STAFF RECOMMENDATION
235 Lauderdale Road
August 21, 2019

Application: Violation; New Construction—Addition; Partial Demolition
District: Cherokee Park Neighborhood Conservation Zoning Overlay
Council District: 24
Map and Parcel Number: 10312008200
Applicant: Brittany Benson
Project Lead: Melissa Sajid, melissa.sajid@nashville.gov

Description of Project: The applicant has demolished an existing pediment above the front door of a contributing building and constructed a front porch. The work was undertaken without any permits.

Figure 1: 235 Lauderdale, July 2019.

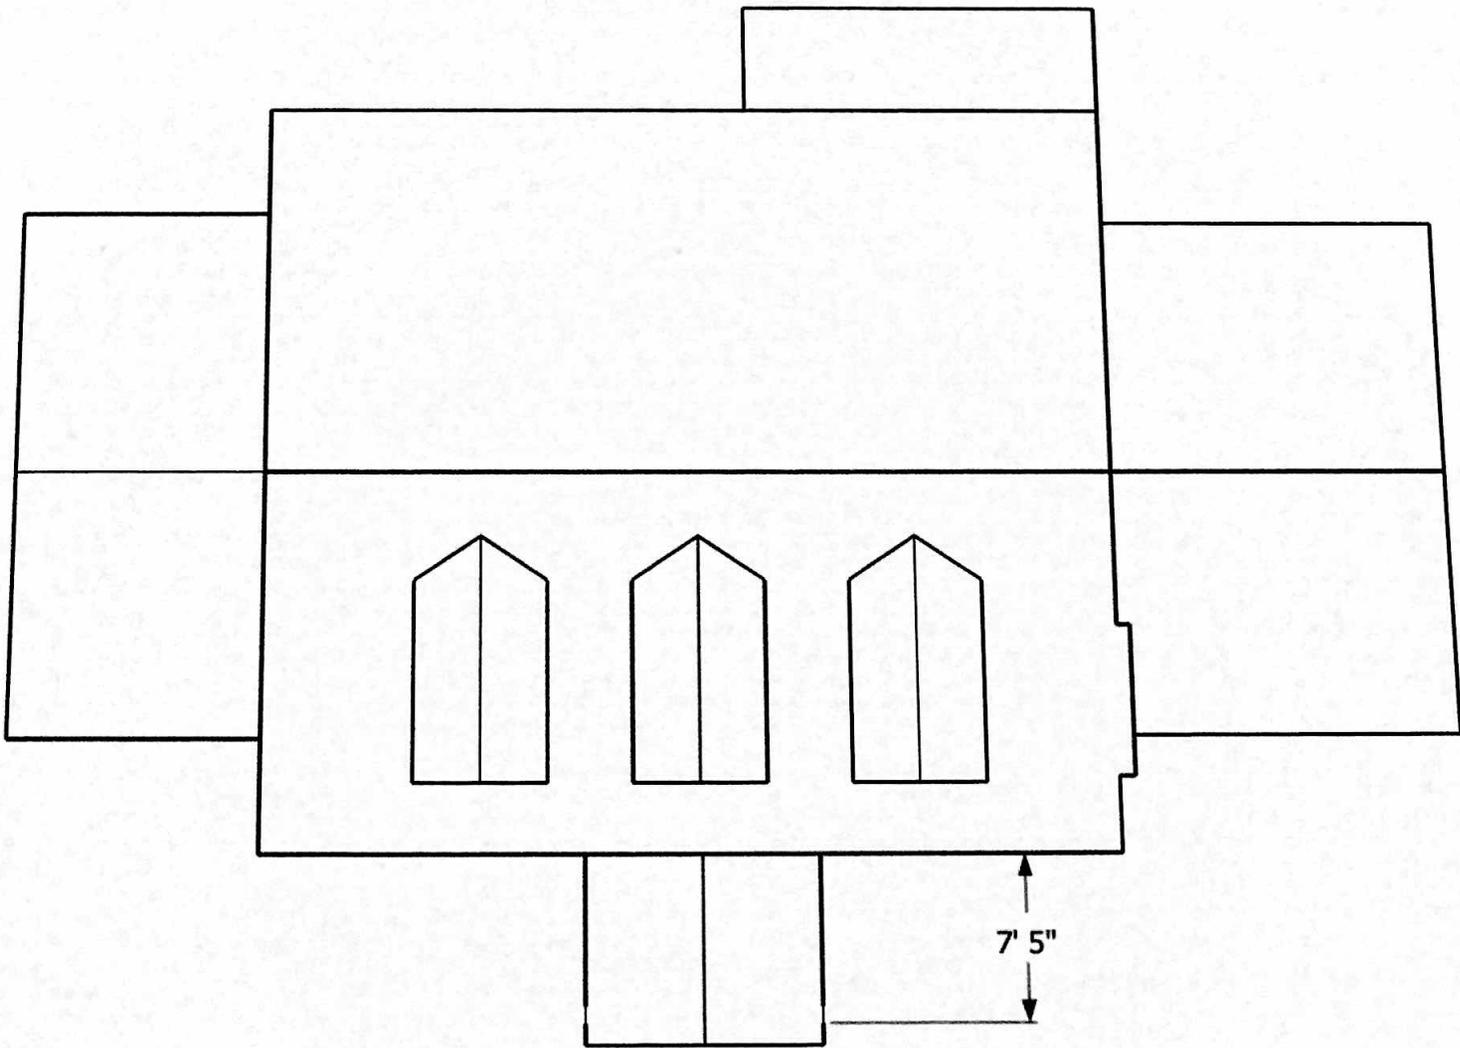
A new front porch was constructed, and the pediment was removed without any permits (Figure 1). The earliest photo available is the 1968 photo from the Property Assessor; it shows the same front entry configuration that was there until the recent changes were made (Figures 2 and 3). The front façade including the front door surround appear to be the same as what was there prior to the construction of the front porch. The trim on the sides of the door remains but has been painted.

Location & Removability: Generally, an addition should be located at the rear of the building in a way that will not disturb the front façade. The front porch addition is not appropriate as it alters the design of the front of the historic building. Since the porch addition required the removal of the existing pediment it is not possible to remove the proposed porch in a manner that preserves the original look and configuration of the character defining stoop with pediment. The project does not meet Section II.B.2.a and e.

Design: The project is to place a historic design on a historic house of a different style. The proposal includes a craftsman-style porch, but the house is an English cottage style home. In addition, the project required the removal of a historic feature since the addition required the removal of the historic pediment. For these reasons, staff finds the design of the front addition to be inappropriate and to not meet Section II.B.2.a and f.

Roof form: The porch itself is not appropriate, as discussed previously. The pediment was gabled with a slope similar to the existing front dormers. As constructed, the front porch is also gabled but appears to have a lower pitch. The proposed roof form proposed is not appropriate, and the project does not meet Section II.B.1.e.

Recommendation: Staff recommends disapproval finding that the new front porch does not meet Section II.B.2 for additions. Furthermore, staff recommends that the front porch be removed within thirty (30) days.
